ADDENDUM NO. 04

Northland Corridor Redevelopment Project Phase 4
631 Northland Ave.
Buffalo, NY 14211

Project No. 432607

Project Northland Corridor Redevelopment Phase 4 (BUDC) Addendum No. 4
631 Northland Avenue, Buffalo, NY Contract -
Wendel Project No. 432607 Date 10/31/25

A101B

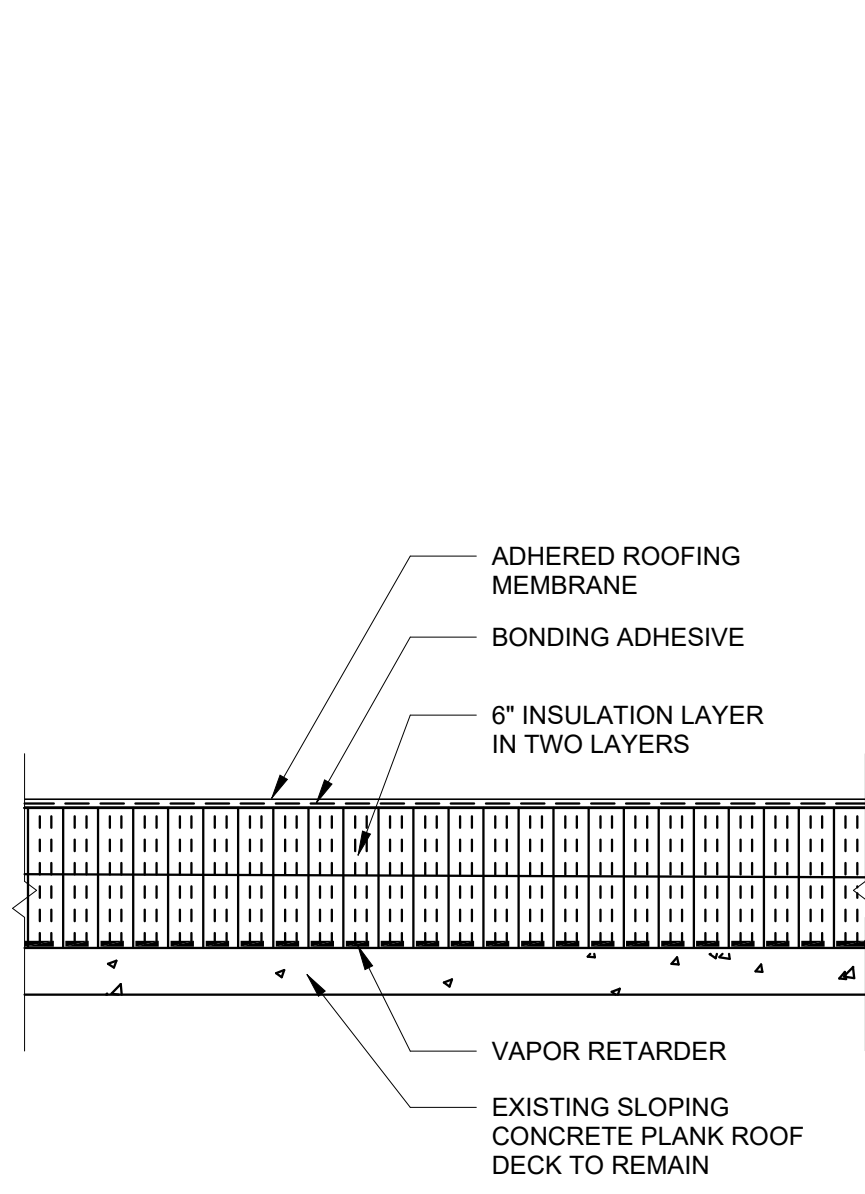
QUESTION: Please provide details for the two railings shown on Drawing A101B and 2/A311 on column line 8.5 from I to J.

ANSWER: Please refer to revised drawing A101B and newly added drawing A454.

REPLACE: Drawing A101B with the revised and Drawing Cover Sheet adding the newly added sheet issued as part of this addendum.

13 ROOF EDGE DETAIL AT CANOPY
SCALE: 1 1/2" = 1'-0"

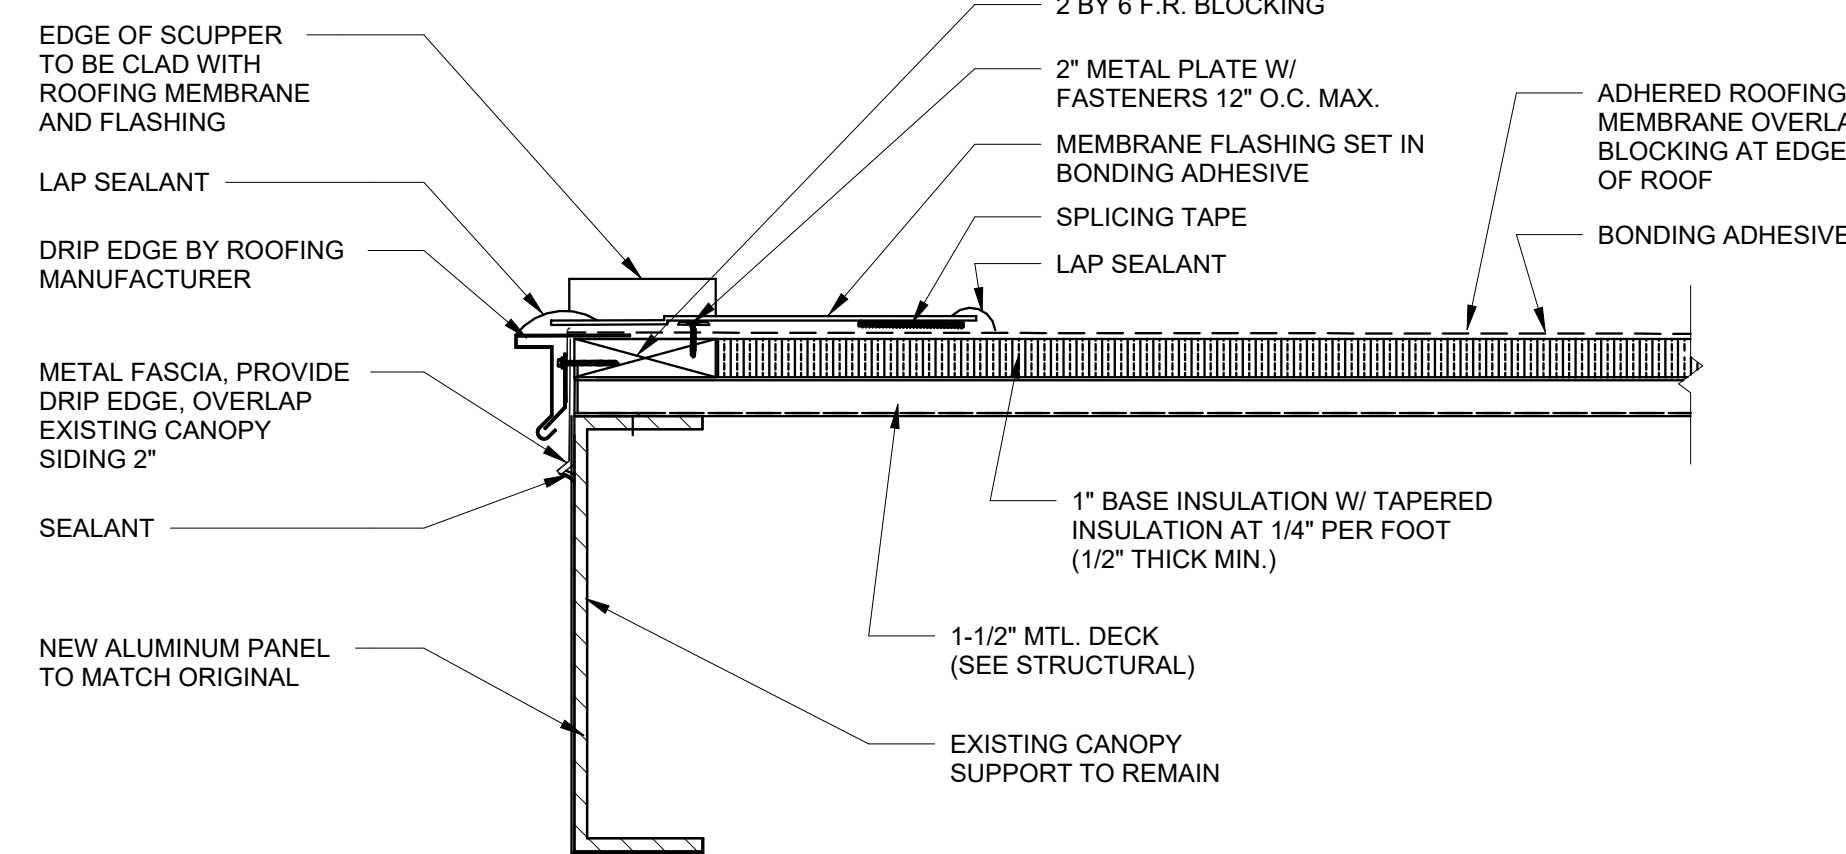
1. Drawing A301, Note C08 calls for metal roofing. Can you please provide a specification for this?
2. There is a section cut through this metal roof, Detail 13/A451 and the detail shows a membrane roof, not a metal roof. Please advise which is correct.

1. Refer to Structural drawings and spec section 053100 Steel Decking.
2. Please refer to the revised drawing sheet A-451 for clarification. The membrane roof is on top of the metal roof and used to pitch the roof.

REPLACE: Drawing A-451 with the revised attached as part of this addendum.

DOOR TYPES
SCALE: 1/4" = 1'-0"

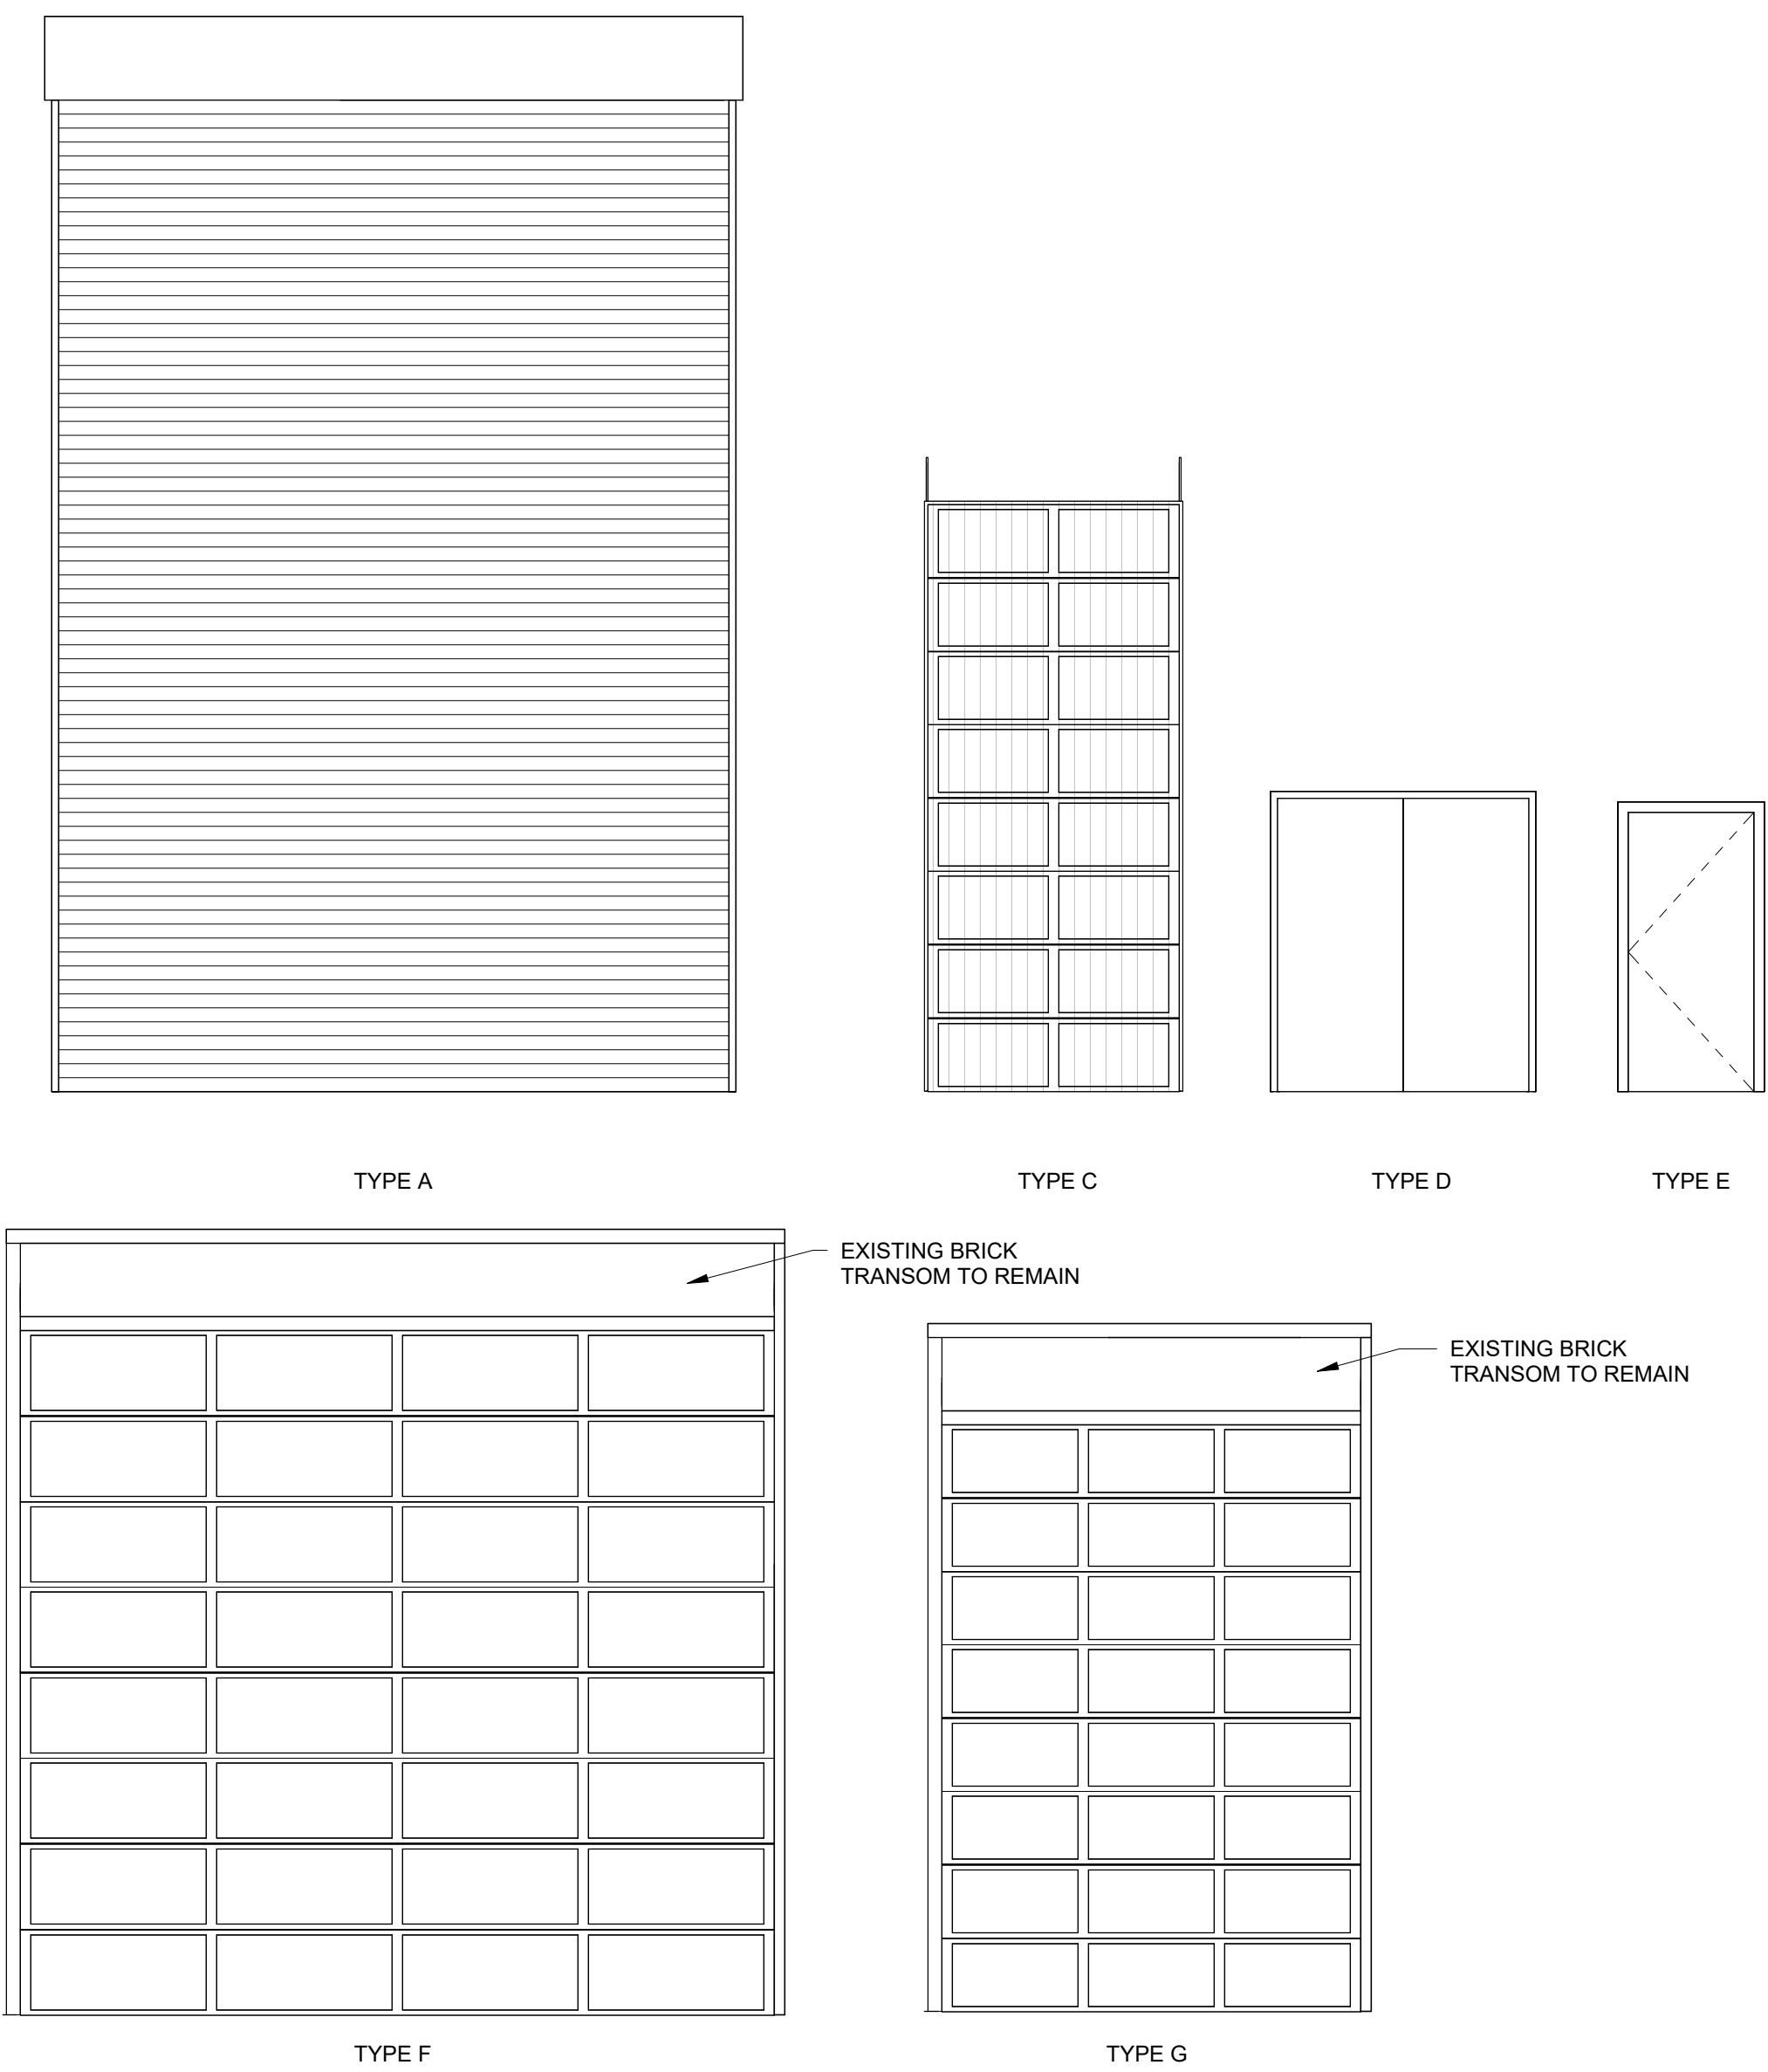
1. Can you please provide hardware sets for each of the openings?
2. Drawing A-900 shows an elevation for Door Type C. Where does this door go? Door Type C is not shown on the Door Schedule. Can you please provide further information for this door?

1. Hardware sets for openings are included in spec section 087100. Please refer to the attached revised section.
2. Please refer to drawing sheet A-900 updated with OH Door Type 'C' location on the west facade and labeled SO4.

REPLACE: Drawing Sheet A-900 revised and included in this addendum.
